MEMORANDUM

TO: Planning Commission
FROM: Lina Smith, Associate Planner
DATE: February 6, 2023
SUBJECT: Floor & Décor (DR2022-0078 / PD2022-0006) – Additional Public Comments and Oregon Department of Transportation (ODOT) Comments
ATTACHMENTS:
Exhibit 2.2 Public Comments from Randy McCourt
Exhibit 4.1 ODOT Comments

DR 2022-0078/PD 2022-006: Floor & Décor Comments

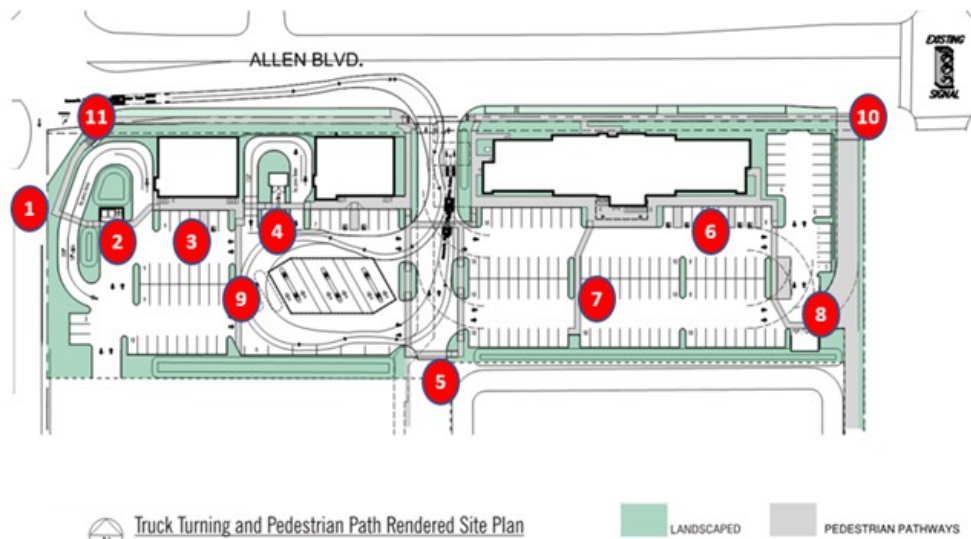
1. Access to the Peppertree Inn. This existing site represents a customer base to your proposed pads. Yet the sidewalk link in the plans stops adjacent to the drive-thru. Extending the sidewalk 5-10 feet to the Peppertree parking lot opposite their porte-cochere would accommodate this. There is an existing asphalt trail around their site just north of that point., A curb ramp connection along their fire lane curb would serve this need. Secondly, there is likelihood in the future that the Peppertree Inn driveway will be limited to right-in/right-out only access as it is too close (only 250') to the OR 217 NB/Allen off-ramp to meet OAR 734-051-4020(8) which specifies 750 feet spacing to full access points from interchange off-ramps. Because of this, the grade in the area just north of the three parking spaces next to the drive thru lane should be set to allow a future potential shared access point (24 feet). This shared access could be established now or later when criteria demand the change.

2. Pedestrian Path. Having the pedestrian path go behind the screened dumpsters rather than in front of them is a better experience for the users. The dumpsters will still have access to the enclosure via the parking lot. This would result in a more direct pedestrian path, adjacent to the drainage feature. Also, consideration of raising the pedestrian path across the two drive through road points would assure slow speeds and better pedestrian access (flat). With the drainage feature adjacent, drainage should be straight forward.

3. Pedestrian Protection/ADA Access. The plan does not show a curb ramp to the accessible parking - indicating a curbsless environment - good for pedestrian access. However, if wheel stops were being considered - these create tripping hazards, not good for elderly users and contrary to ASTM F1636-21. They have been removed from ADA sample plans. Better is the application of bollards which can double as sign posts for accessible parking spaces and for pedestrian protection from vehicle encroachment strikes near entryways (which unfortunately is not uncommon). The bollards can be designed to meet ASTM 20 mph encroachments using 6" schedule 80 pipe, 36" above ground, 48" below ground in a 18" drilled shaft in front of each parking space (with a durable

plastic sleeve - see below). A proper use of wheel stops is where pedestrians are not allowed to walk - as shown (potentially) on the southern side of the parking lot opposite the hotel as a border condition, draining into a swale area that does not permit pedestrian passage.

4. Minimum Sidewalk. Minimum sidewalk width should be 6 feet .This does not appear to be the case here. Particularly behind the curb ramp shown. If the 6' sidewalk cannot be maintained, flush sidewalk/parking with bollards might be considered.

5. Sidewalk to Parcel C (south): The transition of sidewalk spaces heading south to parcel C (5.3 acre area to the south of the sketch) are not clear - they should stub and stop at the southern parcel line as either curb tight or buffered (preferred) sidewalks to the circulation roadway within the parking lot. This sidewalk should eventually extend and connect to the existing Fanno Creek trail stub in the SE corner of parcel 3. Parcel 3 will need this link so their folks can access the trail - as well as folks from parcel 1.

6. Pedestrian Protection/ADA Access. Same as #3 above.

7. Pedestrian Path Alignment with Destination. The pedestrian path through parking should align with the front door of the building and the landscaped parking spaces should move with them (shift ~30' west to align directly). If the front door is curb high, a raised pedestrian crossing (3-6") should be considered in the parking lot for this path to act as traffic calming.

8. THPRD Trail Connection. The pedestrian link to the THPRD trail link is not clear - this should be a sidewalk connection. A direct connection should be considered from the face of the future hotel extending the sidewalk across the dead end parking lot aisle in line to the trail. If a fire/maintenance access to the trail is provided - it will likely be gated and not conducive to pedestrian access and not the direct path to the business customers that the sidewalk, in-line would provide. The planter island could be shifted to straddle the sidewalk.

9. Pedestrian Path in Parking Lot. If this pedestrian way is a sidewalk (should be) it should have raised pedestrian crossings to keep vehicle speeds down in the parking aisles (could be 3" high and configured with adequate drainage).

10. Link to Allen/Bus Barn Signal Pedestrian Crossing. The detail of how the sidewalk along the south side of Allen Blvd connects to the trail and how it connects to the adjoining property to the east and the traffic signal are not clear.

While some of this may be addressed with the THPRD Trail work, the stubbing to the connection should be set up. That would mean a 12' asphalt trail behind the bus stop to the SW corner of the Allen/Bus Barn signal. Maybe it is just arrows or maybe it is this work - but either way, acknowledging the connection is key so it flows between plans.

11. Curb Ramp at Peppertree Driveway. The termination of the Allen Blvd sidewalk at the Peppertree Inn driveway (in public ROW) needs to be ADA accessible. It does not have a tactile warning surface. The plans do not show this detail. The sidewalk fronting Allen Boulevard should be 6 feet wide.

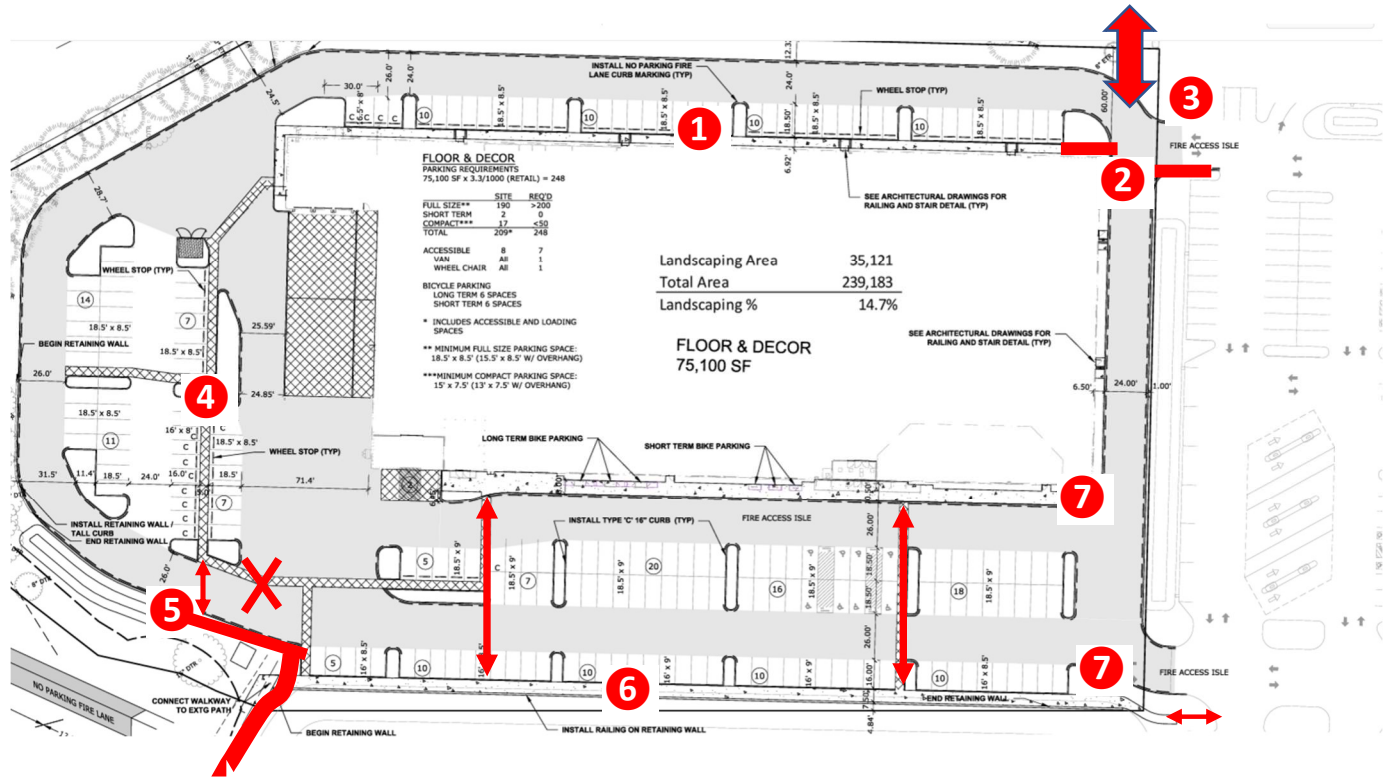
- 1 This parking stall should not have wheel stops as they would be in the pedestrian path from cars to sidewalk. Since the area is either paved asphalt or concrete – extend the concrete sidewalk to 8.42' and reduce the parking stall to 16' which accomplished that same outcome with the same pavement without the tripping hazard (not complying with ASTM 1636-21 which says to avoid wheel stops). The wider sidewalk has greater utilize than a longer parking space with a wheel stop in it.

- 2 The sidewalk terminates in an illogical location. The sidewalk should extend north with ADA curb ramps across to the side adjacent to then north where restaurants and retail are being built (noted by red stubs)

- 3 There is likelihood in the future that the Peppertree Inn driveway will be limited to right-in/right-out only access as it is too close (only 250') to the OR 217 NB/Allen off-ramp to meet OAR 734-051-4020(8) which specifies 750 feet spacing to full access points from interchange off-ramps. Because of this, the grade in the area just south of the three parking spaces (on the site immediately north) should be set up to allow a future potential shared access point (24 feet). This shared access could be established now or later when criteria demand the change (depending upon the City and ODOTs consideration).

- 4 The combination of wheel stops in a pedestrian space is a potential tripping hazard. This should be raised sidewalk that consumes the same space as the walkway plus the overhang areas – eliminating the wheel stops. No increased paved area, just concrete sidewalk replacing paved asphalt – with ADA curb ramps at each end point.

- 5 Pedestrian space in the middle of vehicle aisles is not acceptable (take them out – red x). Replace them with crossings (potentially raised pedestrian crossings (3 to 6 inch) with ADA access across the parking area where the three arrows indicate (providing speed management also). A new sidewalk linking to the Fanno Creek Greenway Trail (minimum 6' behind the curb) should be added.

- 6 The vehicle overhang wipes out the pedestrian way. The sidewalk must be 10 feet to address vehicle overhang. This should extend to the site to the north and connect to the ADA curb ramps.

- 7 ADA ramps at corners
